**49 CFR Part 571**

**Motor Vehicle Safety Standards; Electronic Stability Control Systems for Heavy Vehicles**

**ACTION:** Final rule; response to petition for reconsideration.

Figure 1. J-turn Test Maneuver Course (shown with the curved lane section in the counter-clockwise direction – the test is conducted in both the counter-clockwise and clockwise directions)

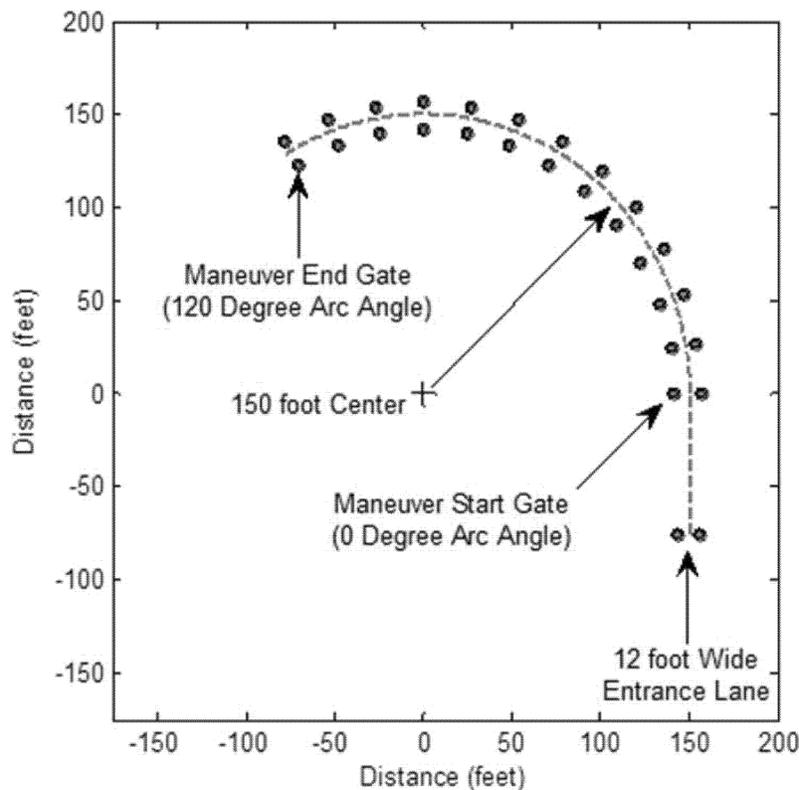
EMA asserted that the curved section of the 12-foot-wide lane is too narrow, and therefore, it is impracticable for the testing of a long wheelbase truck tractor

with a wheelbase equal to or greater than 7112 millimeters (280 inches). EMA stated that it was challenging for the drivers of tractors with wheelbases larger than 280 inches to complete the maneuver in the 12-foot-wide lane, because there was not an adequate margin of physical space to account for test variability. EMA listed factors that contribute to the variability of its test results which included: (i) The length of the tractor's wheelbase, (ii) the experience level of the test driver, (iii) whether the maneuver is conducted in the clockwise or counter-clockwise direction, and (iv) other vehicle attributes such as steering system, suspensions, axles, and tires. EMA has shown that there are dimensional limitations for certain long wheelbase truck tractors to conduct the J-turn test maneuver within 12-foot-wide lane and a larger lane width is needed to adequately test the ESC systems.

In support of the petition for reconsideration, on June 30, 2016, EMA submitted data from testing and computer simulations indicating that a lane width of 4.3 meters (14 feet) was necessary for these long wheelbase truck tractors. EMA tested three truck tractors with three test drivers of varying degrees of experience in conducting the J-turn maneuver in both directions (clockwise and counterclockwise). EMA also performed computer simulations on three example tractors to do a static analysis showing the clearance of the truck tractor within the lane. Based on engineering recommendations from all of the major heavy-duty tractor manufacturers using the results of the computer simulations and the vehicle testing, EMA requests that truck tractors with a wheelbase equal to or greater than 7112 mm (280 inches) be conducted on a J-turn test course with a lane width of 4.3 meters (14 feet).

In order to ensure that the J-turn test maneuver tests the ESC system and not a test driver's ability to maintain a narrow lane, NHTSA will adopt EMA's suggested 4.3 meter (14 foot) lane width for testing longer wheelbase truck tractors. Despite the increased lane width requirement for these long wheelbase truck tractors, NHTSA is confident that the ESC systems in these long wheelbase truck tractors will be adequately tested for minimum performance using the J-turn test maneuver because the driver must maintain the lane within the same fixed radius curve and travel at the same minimum test speed as all other truck tractors.

This change requires two clarifications. First, as with buses, the wider lane is used only in the curved section of the test course. The lane width of the straight section will remain 3.7 meters (12 feet). The dimensional considerations that require a wider lane width for long wheelbase vehicles do not apply to straight sections of the test course.

S6.2.4.2 For truck tractors, the lane width of the test course is 3.7 meters (12 feet). At the manufacturer's option, for truck tractors with a wheelbase equal to or greater than 7112 mm (280 inches) the lane width of the test course is 3.7 meters (12 feet) for the straight section and is 4.3 meters (14 feet) for the curved section. For buses, the lane width of the test course is 3.7 meters (12 feet) for the straight section and is 4.3 meters (14 feet) for the curved section.
